Value Engineering Study

**US 27 RECONSTRUCTION
FROM US 150 BYPASS IN STANFORD TO KY 34
LINCOLN AND GARRARD COUNTIES, KENTUCKY**

**ITEM NUMBER 7-196.00
VE STUDY NUMBER 201204**

Final Report

SKETCH OF RECOMMENDED DESIGN

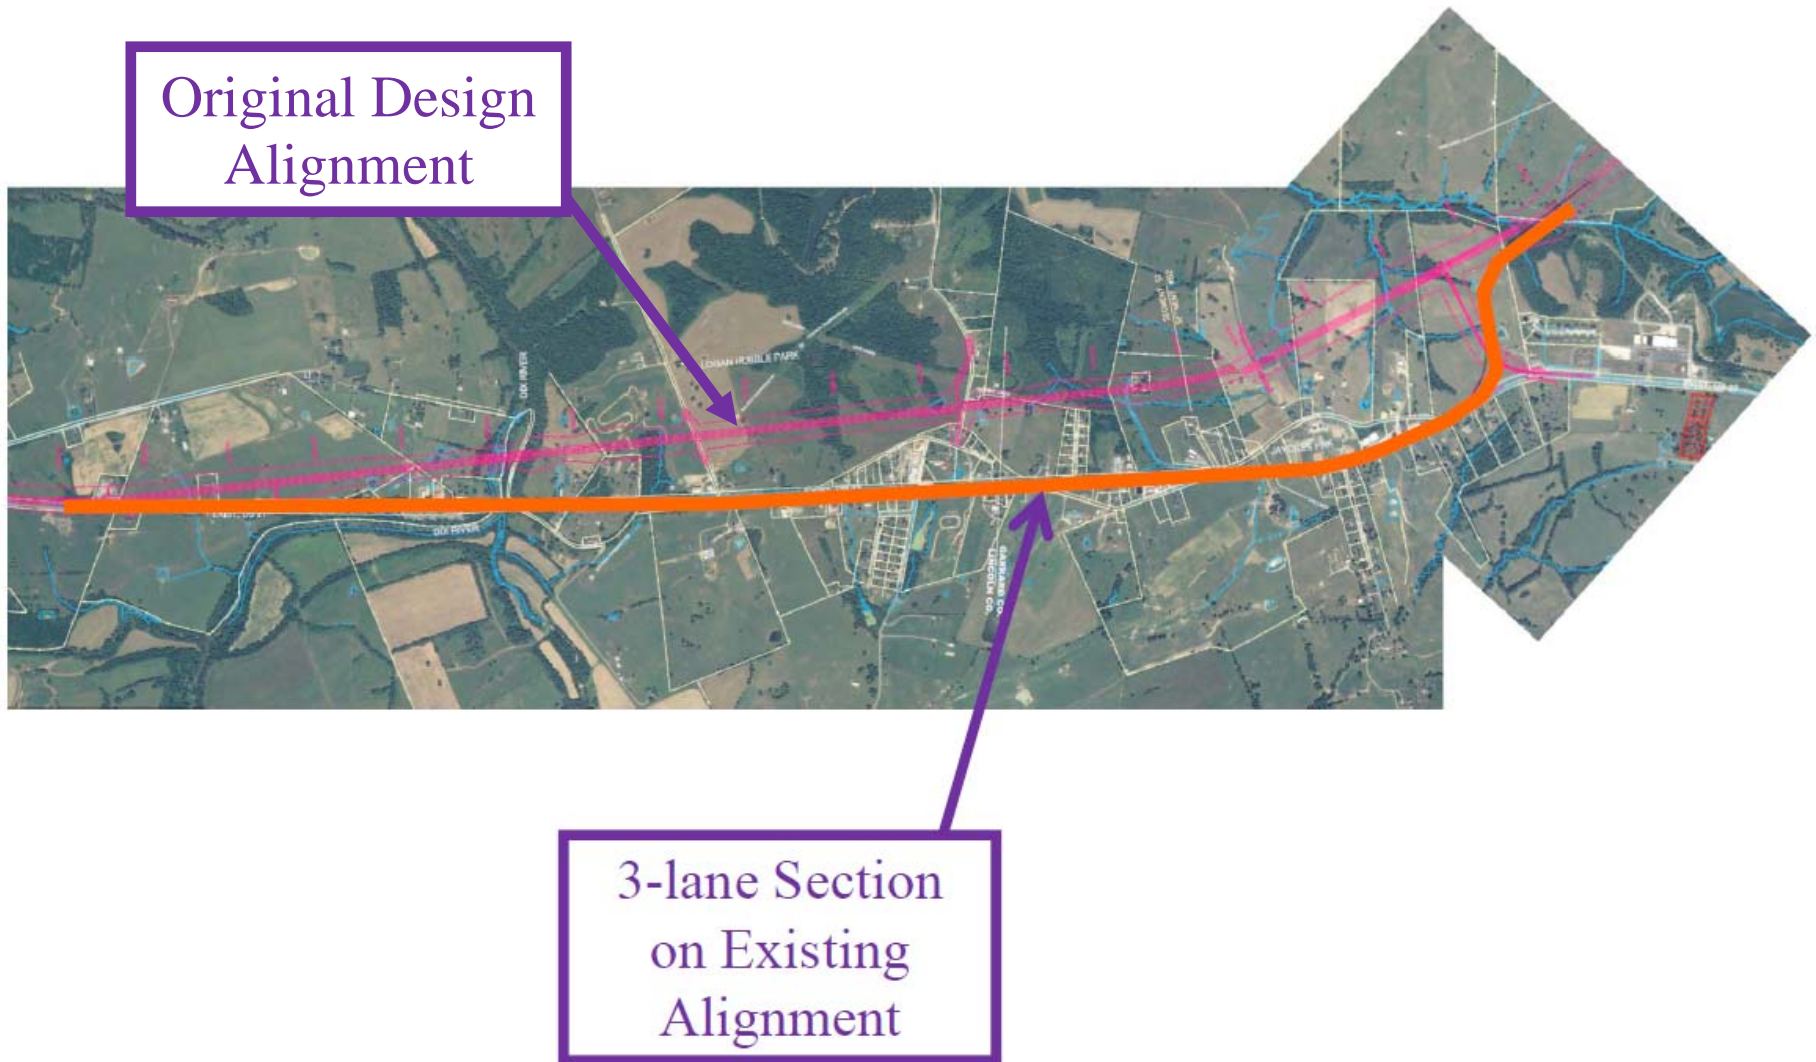
The VE Team recommends the existing alignment be used to widen the existing roadway and bridge to a three lane rural typical section between the referenced stations. Only two areas would need access by permit: Logantown and the Gilbert’s Creek Road vicinity. Access management techniques could be used to achieve 600 feet entrance spacing in most of the other areas; a few frontage roads may have to be built. This would allow partial control of access. In most places, widening could be done on the west side with little impact. The bridge would be totally re-decked, with three additional beams added to the width.

VALUE ENGINEERING RECOMMENDATION # VE-12
SKETCH OF RECOMMENDED DESIGN

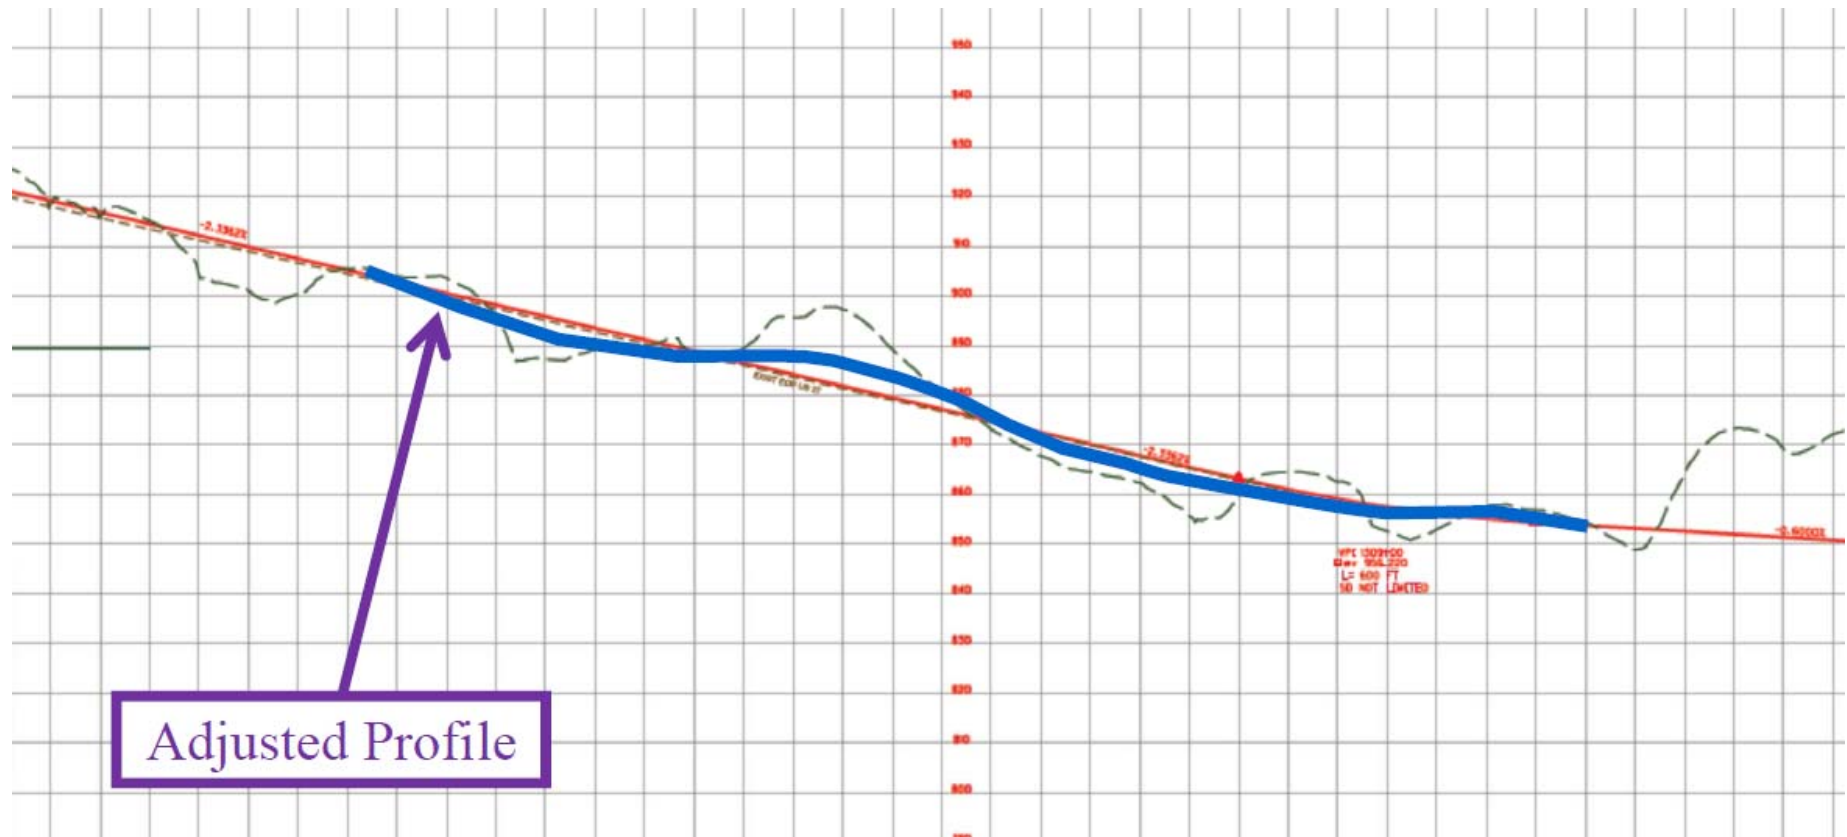
The opportunity for the installation of additional vertical curves could possibly reduce both excavation and embankment in place, thereby reducing costs. The cost estimate was developed assuming a maximum grade of 5%.

There are about 95 vertical topography points on the project. The recommended alternate has about 34 vertical curves. This suggests that an opportunity may exist for additional vertical curves. The VE Team assumes 9 vertical curves can be added to the project. The VE Team also assumes that 36,000 CY of excavation can be saved per additional curve, and 14,000 CY of embankment can be saved per vertical curve. Therefore:

SKETCH OF RECOMMENDED DESIGN

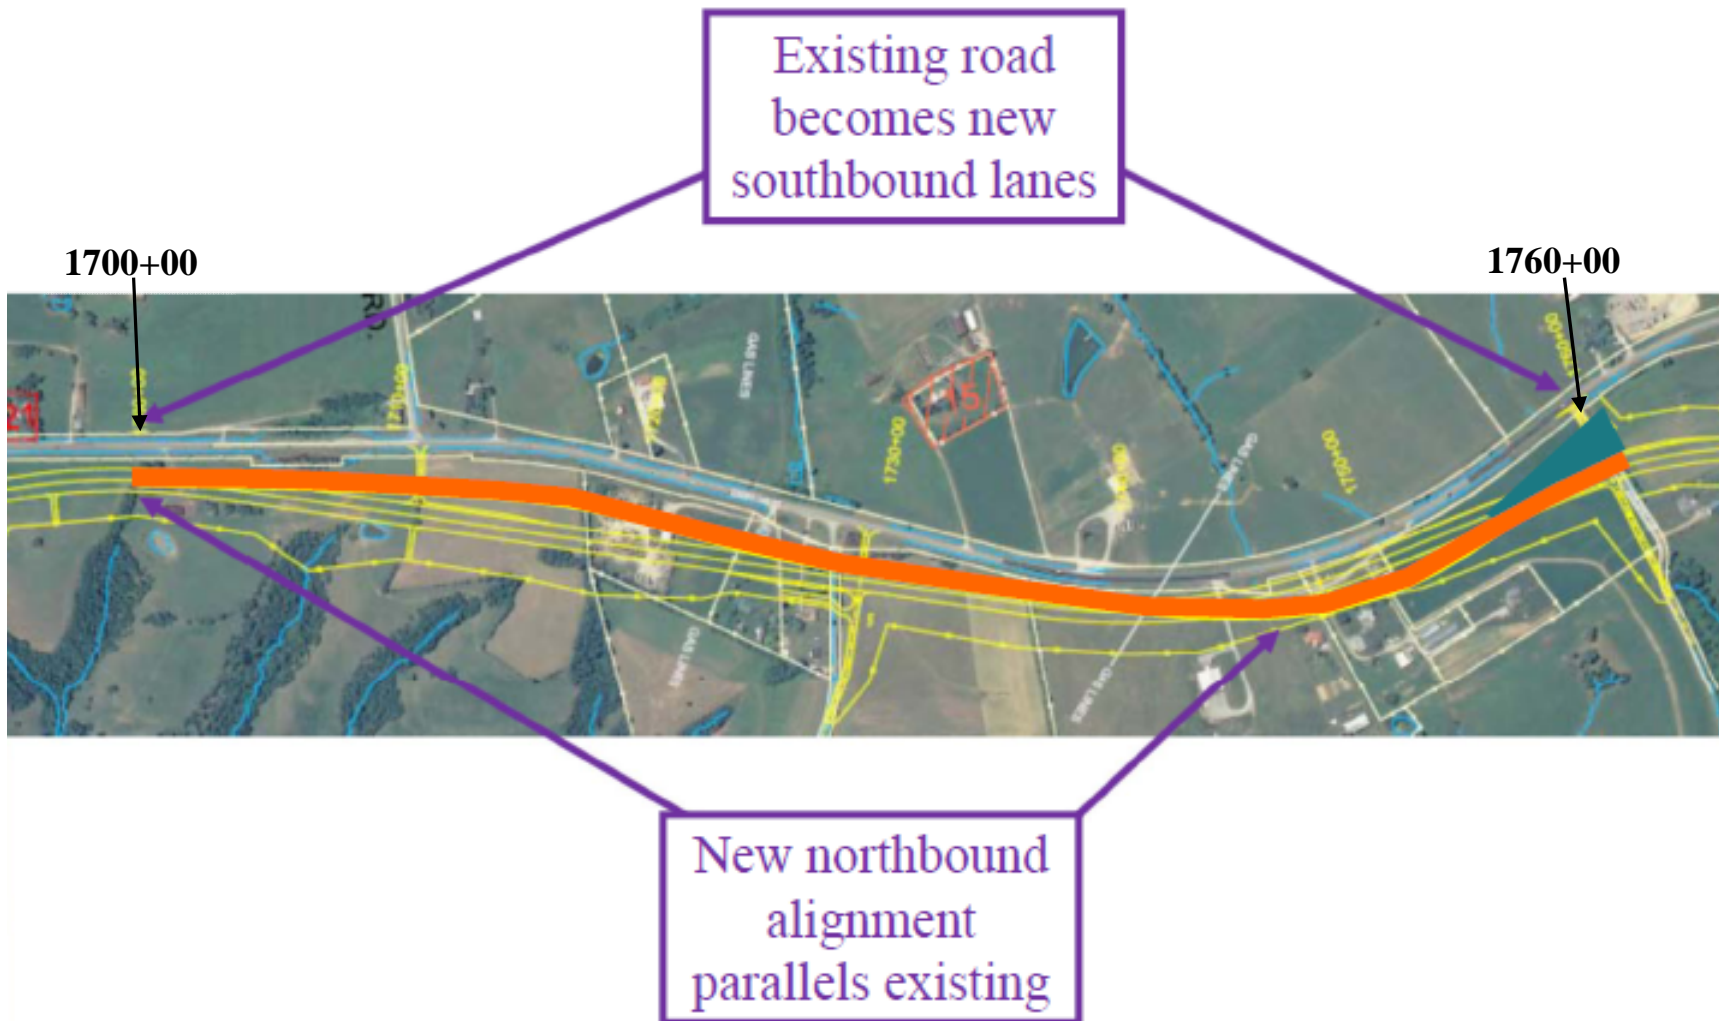
VE-13	Utilize existing road alignment from Sta. 1700+00 to 1760+00 in lieu of new alignment	\$1,400,000		\$1,400,000	2
VE-14	Utilize a 12-foot in lieu of a 14-foot center turn lane in the urban section at the southern end of the corridor	\$137,000		\$137,000	2

SKETCH OF RECOMMENDED DESIGN

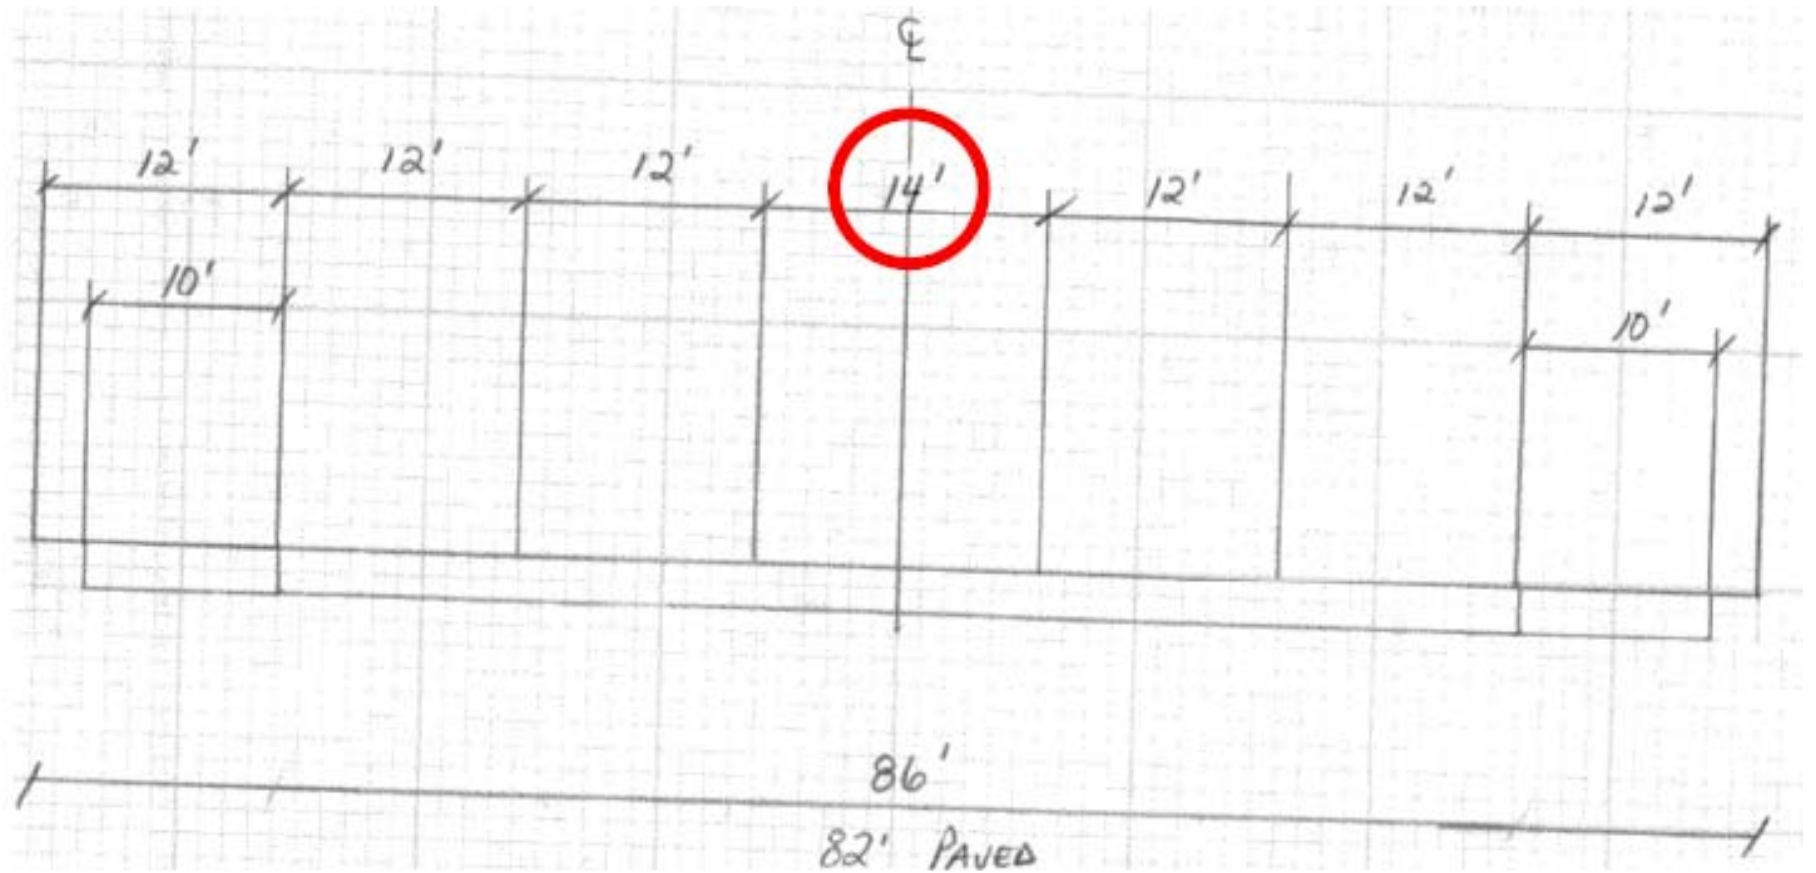
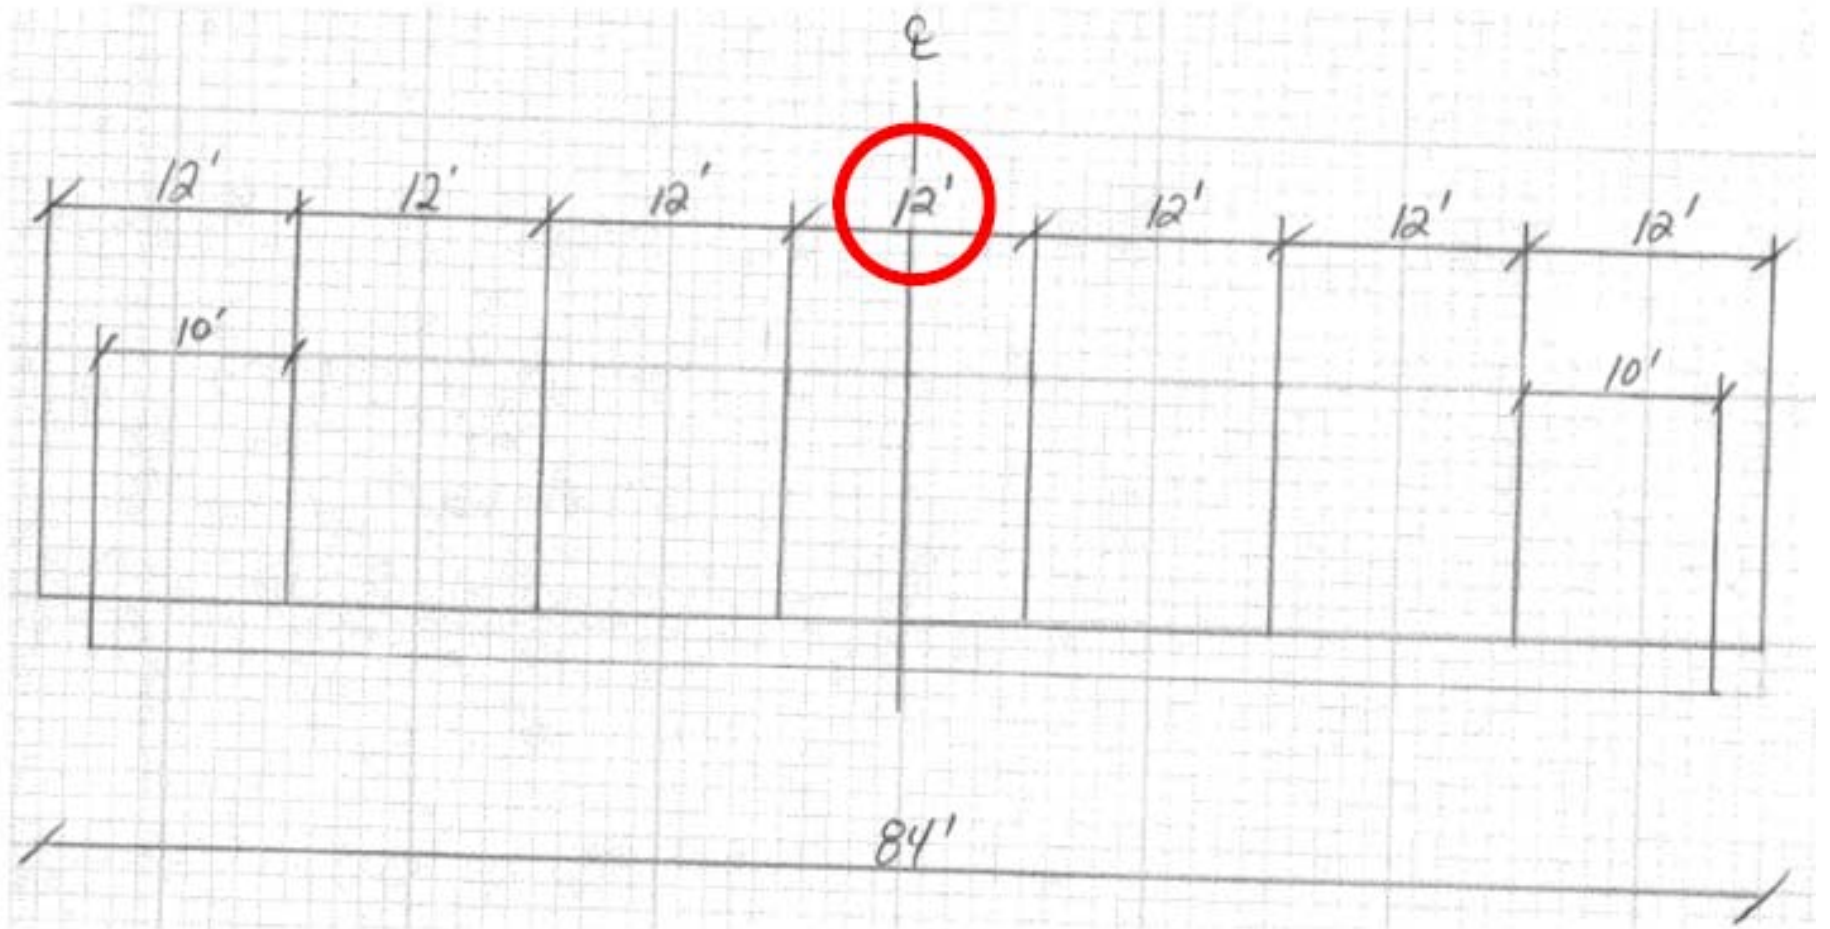
This reduction of the typical section will help minimize the overall cost of the ROW and pavement. ROW and pavement are major costs on this project, and any steps taken to reduce ROW impact and constructed pavement should be considered. This change will not substantially impact the safety or operation of the TWLTL.
